Case N-XXX (07-1682) Nickel Alloy Reactor Coolant Barrier Weld for Mitigation of PWR Full Penetration Circumferential Nickel Alloy Welds in Class 1 Items

Section XI, Division 1 DRAFT Rev B

NOTE 1. CRC ONLAY INCLUD
Examination Volume A-B-C-D in
DMW with Barrier Weld
Figure 2

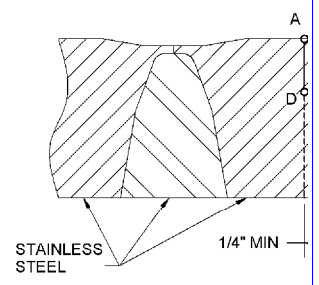
Deleted: Stress analysis of the final configuration shall be performed in accordance with IWA-4311 (see Figures 1 and 2). ¶

Deleted: volume shown in Figures 1 and 2 shall be examined. The examination detection, length sizing and through-wall sizing capabilities and coverage achieved during this examination shall be equivalent to the examinations performed as specified in 5.0(c)(1). Flaws detected in the remaining portion of the DMW prior to the barrier weld being applied shall be essentially equivalent to the flaws detected therein during this examination. Flaws shall not exceed the inservice examination acceptance standards of IWB-3514.

Deleted:
Examination Volume A-B-C-D in
DMW with Barrier Weld
Figure 1
